**City of Portland, Maine – Building or Use Permit Application** 389 Congress Street, 04101, Tel: (207) 874-8703, FAX: 874-8716

REASON FOR PERMIT: extend dormer 10'

REASON FOR PERMIT: extend dormer

DATE: 9 MAR. 98 ADDRESS: 34 Deering Ave.  
REASON FOR PERMIT: Revise dormer Plans.  
BUILDING OWNER: Morse  
CONTRACTOR: Robert's Const. Co.  
PERMIT APPLICANT: Robert Pavao  
USE GROUP R-2 BOCA 1996 CONSTRUCTION TYPE 5B

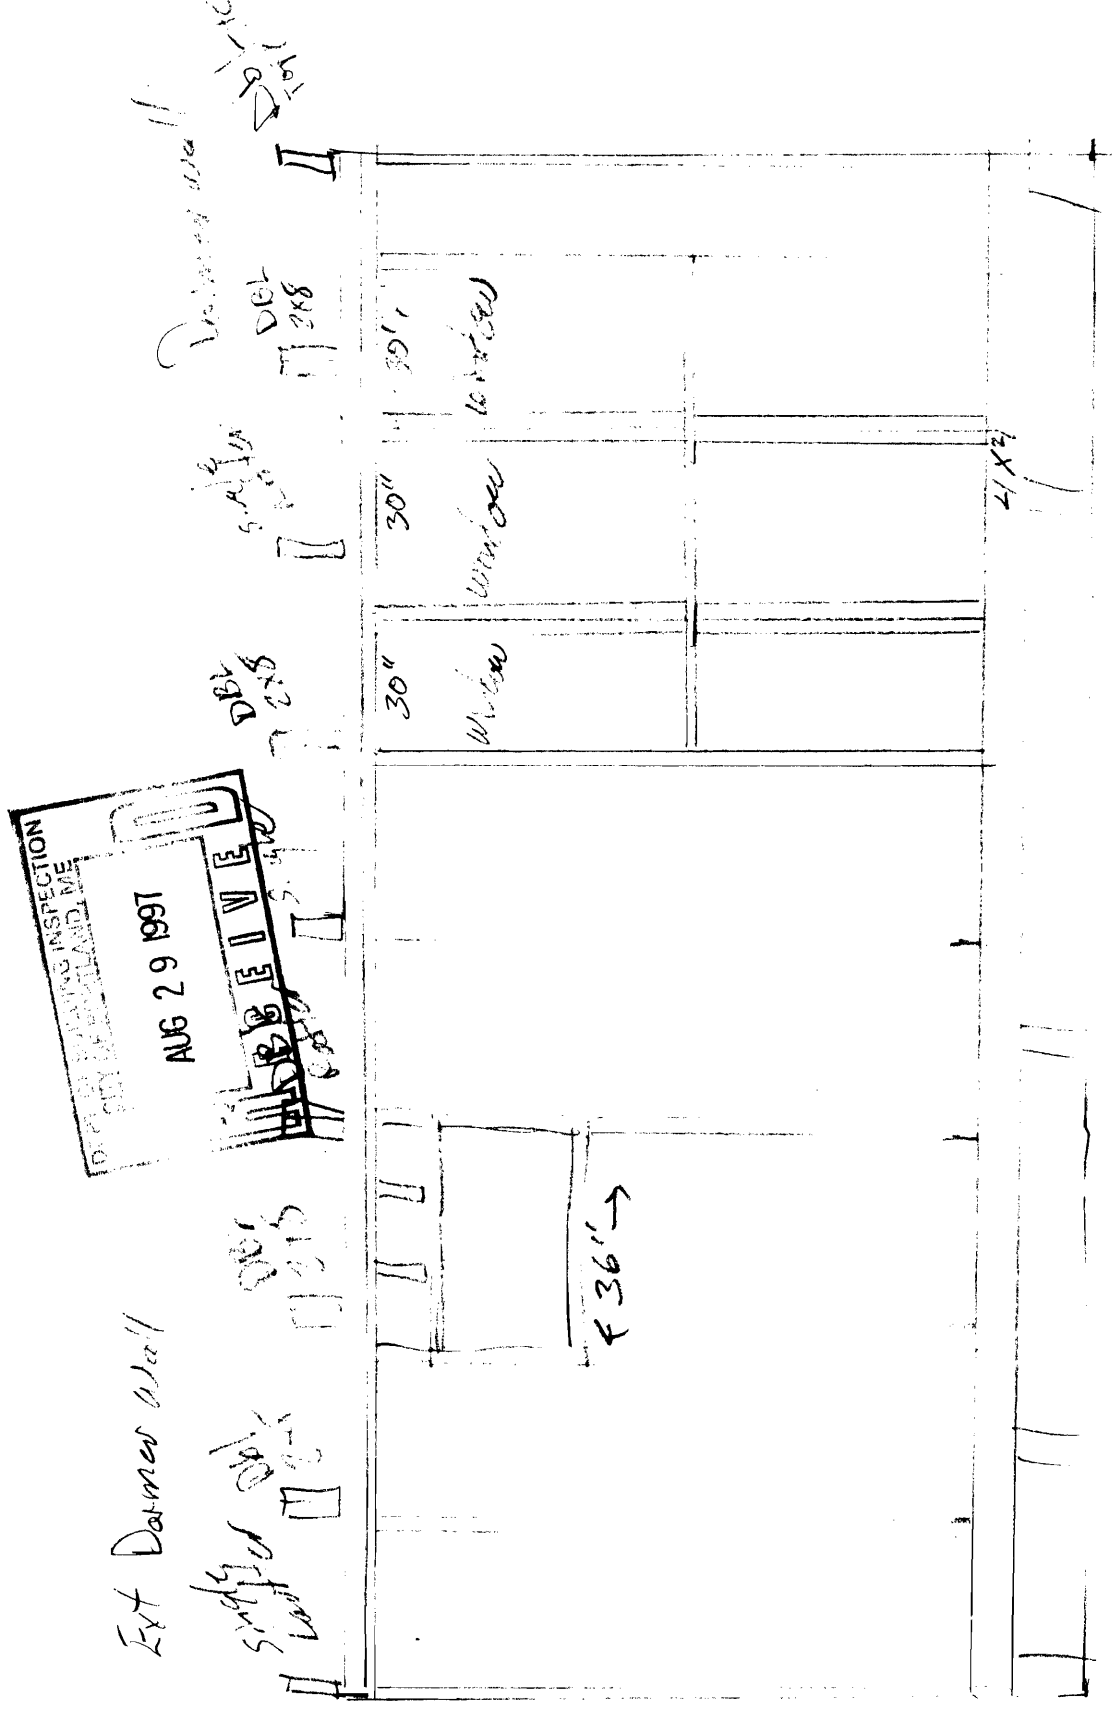
Note 2x8 rafters do not carry roof over studs  
 No Header over both windows  
 Roof is less than 4/12 pitch  
 Rafters 8' span 2x8 e'oe (some n'led)

WINDOW DETAILS

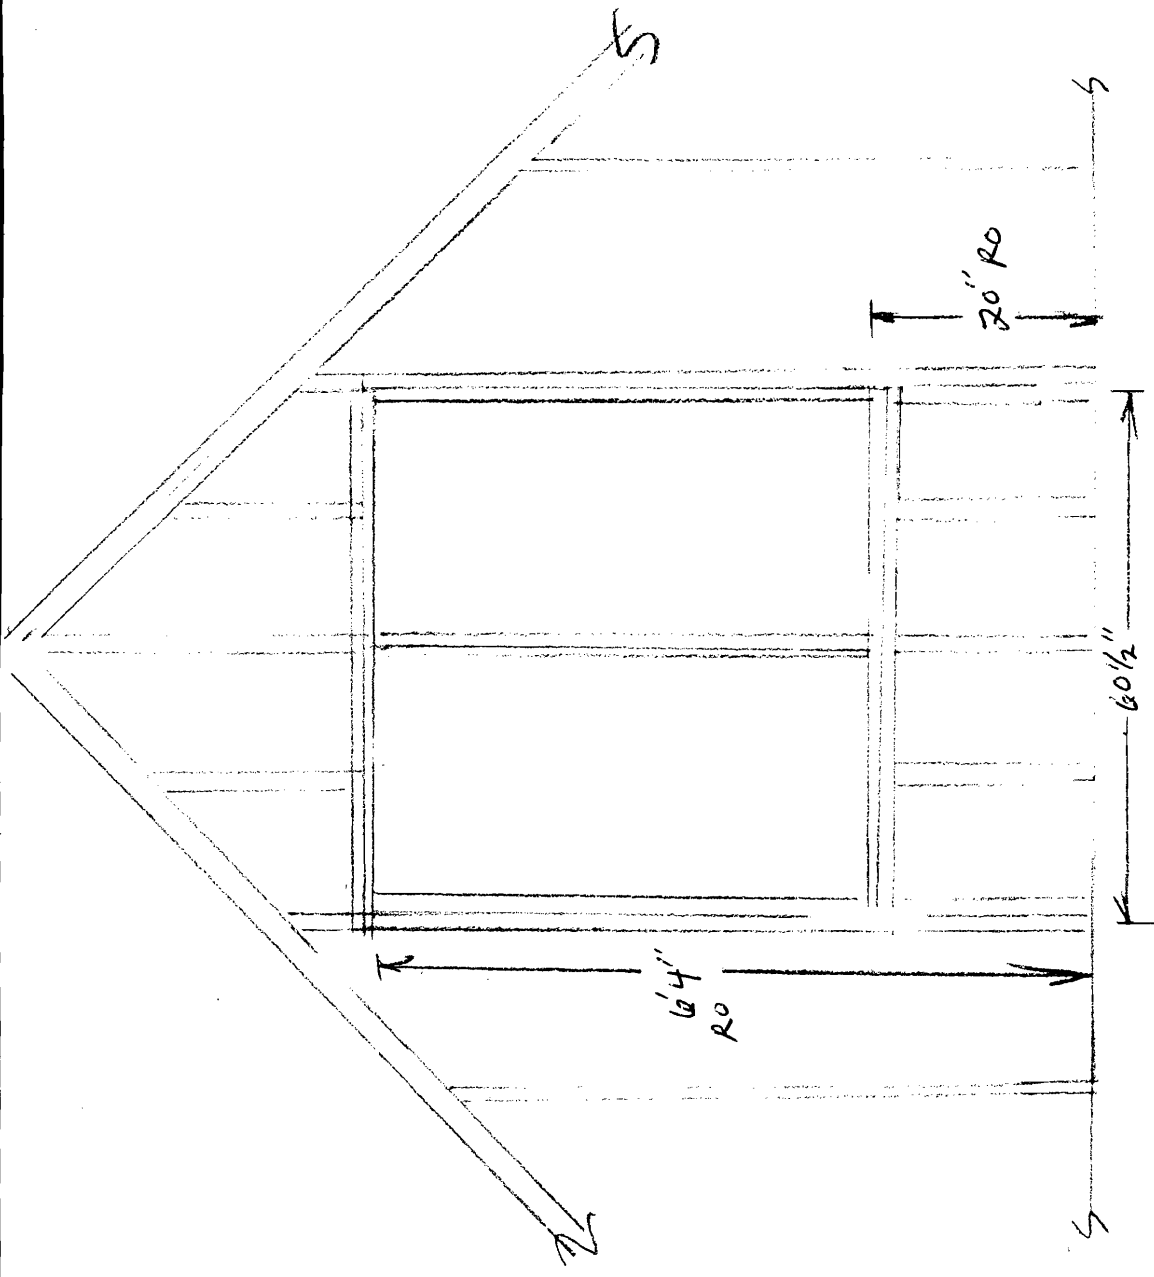
EXISTING DORMER R.O. IS 56 1/2" H x 97" W  
WITHOUT HEADER

REDUCE RO TO 48" H x 97" W  
INSTALL: 6x8x100" HEADER  
DLG JACKS @ 2'6"  
3- 2 1/2x3 9/2 PELLA PROLINE WINDOWS

EXISTING RO IS  
PROPOSED RO IS  
METHOD - CUT EXISTING STUDS  
INSTALL DOL NON-BEARING HEADER,  
JACKS AND CRIPPLES

FINISH - INSTALL 2-35x48 PELLA PROLINE WINDOWS

JOHN TANGWAY STEVE MORSE 34 DEERING AVE. PORTLAND, ME.		
SCALE: NA	APPROVED BY:	DRAWN BY: RJP
DATE: 2/25/98		REVISED:
DORMER ROOF FRAMING, BEARING WALLS AND LOAD ESTIMATE		
ROBERTS CONSTRUCTION 729-8224		DRAWING NUMBER #2

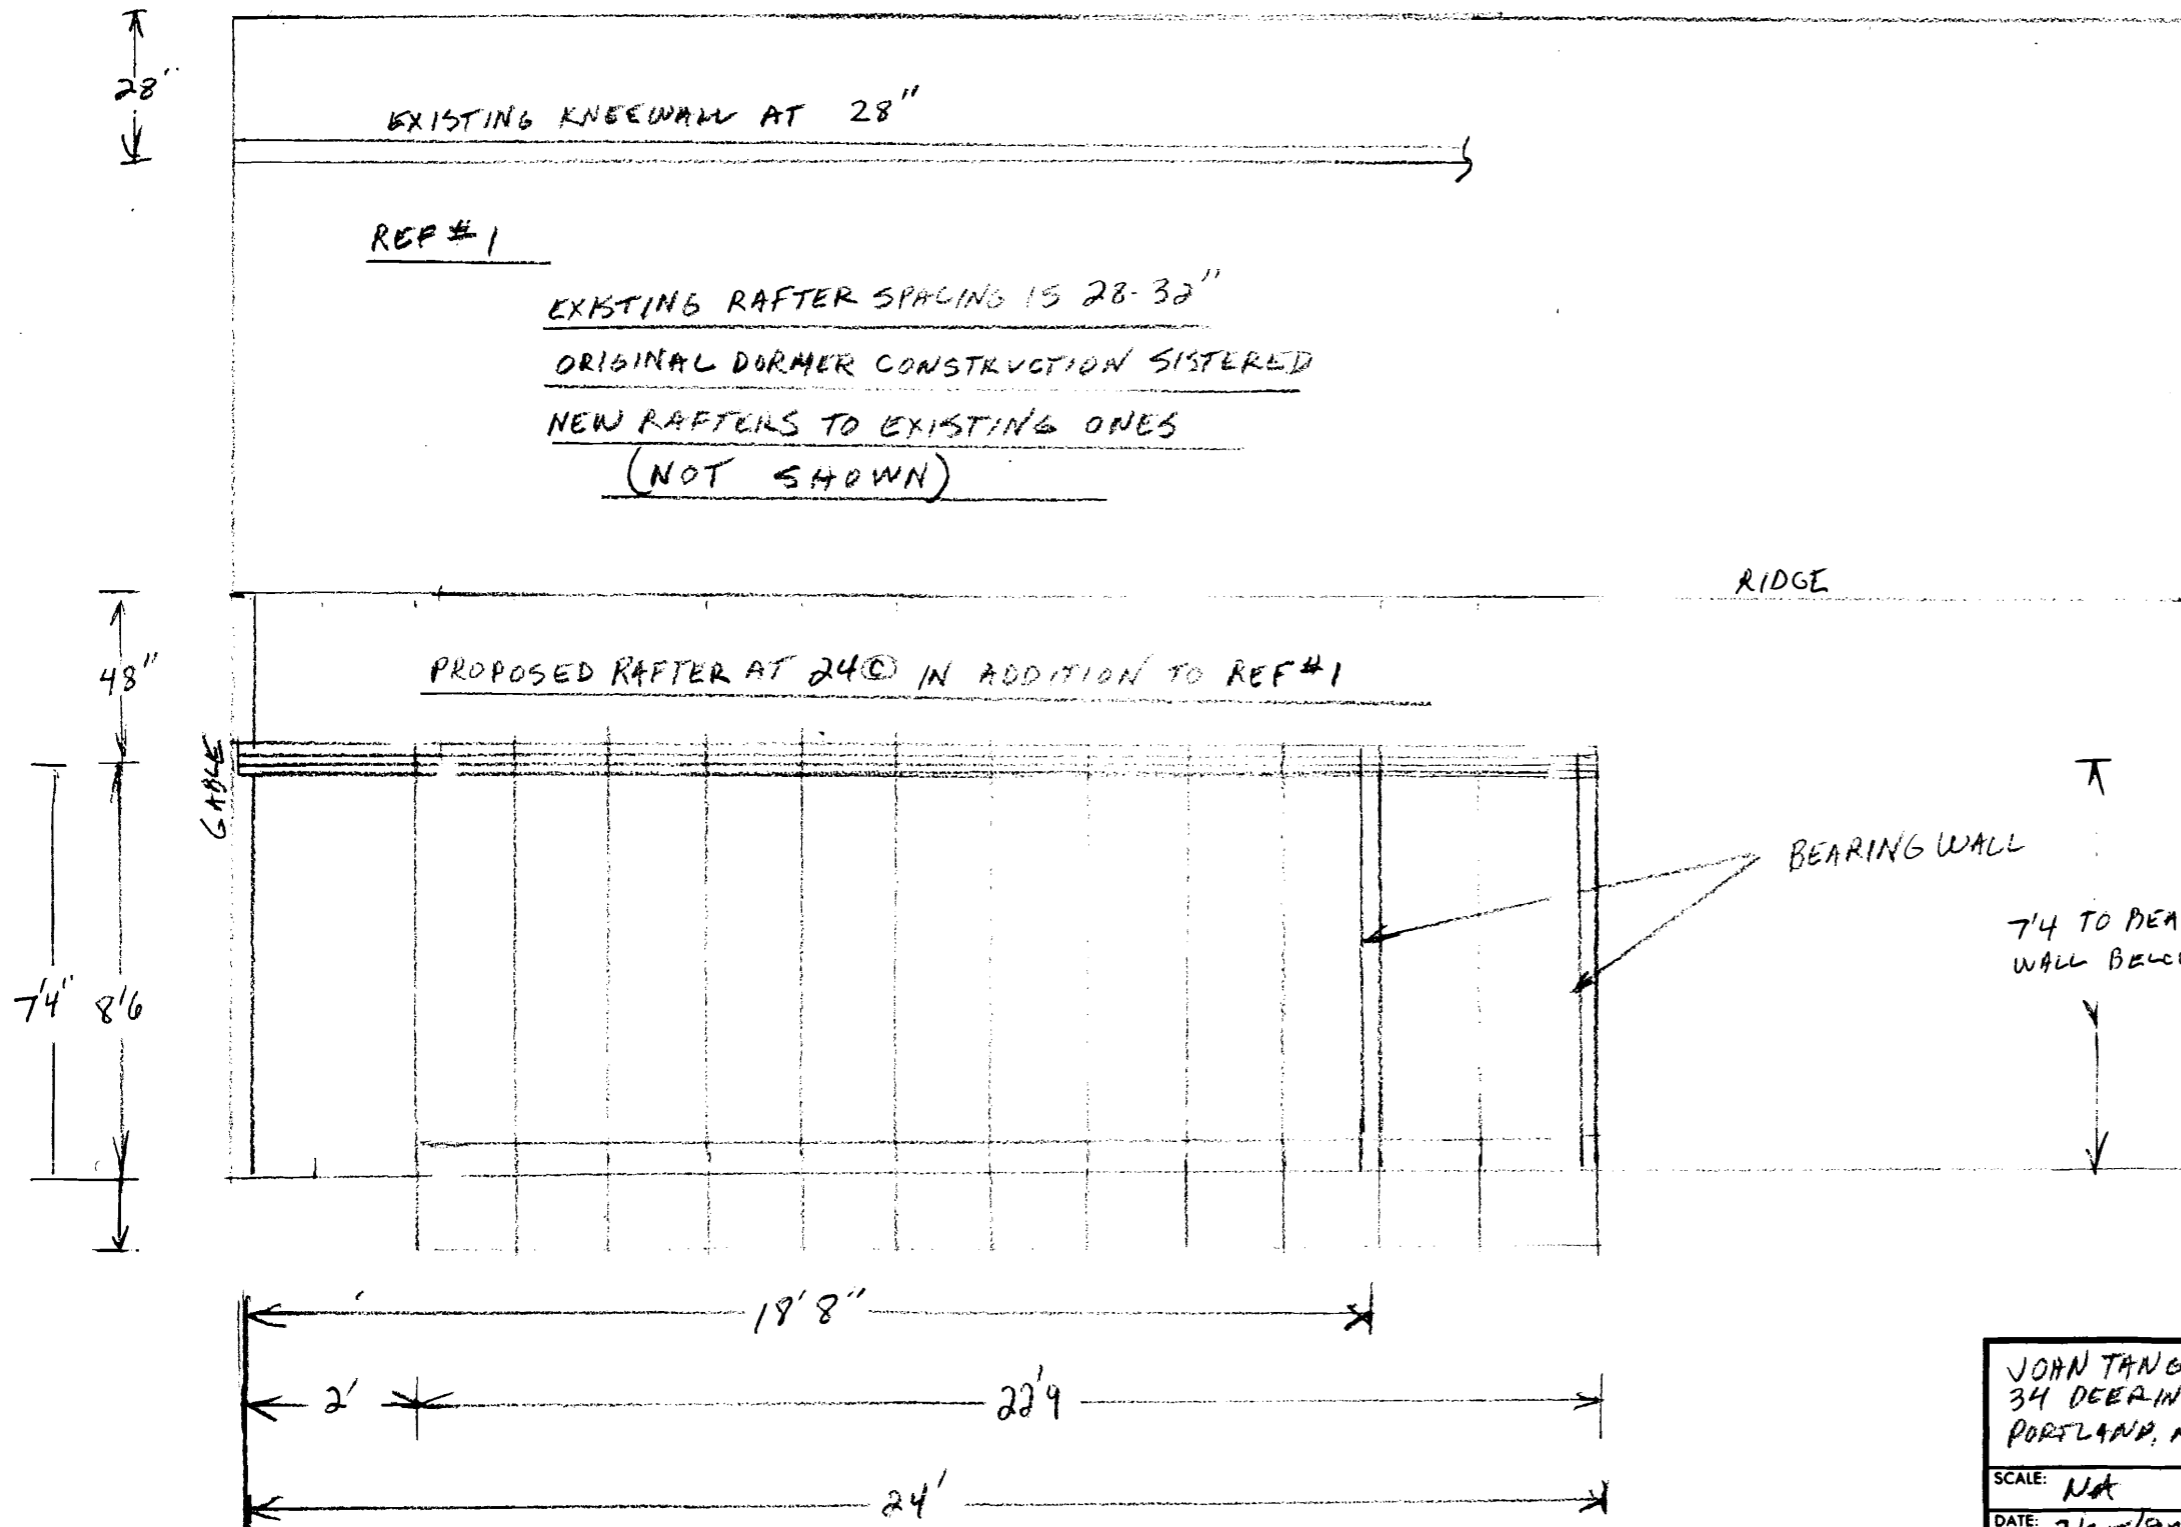
REF 2 LOAD ESTIMATE  
 154 SQ' LOAD AREA  
 8470 PSF  
 2823 PER MEMBER X 3 PCS  
 $2823 \div 24 = 117.6$

CARRYING BEAM TO BE  
 3 - 1 3/4 x 11 7/8 LVL  
 24' L SPAN
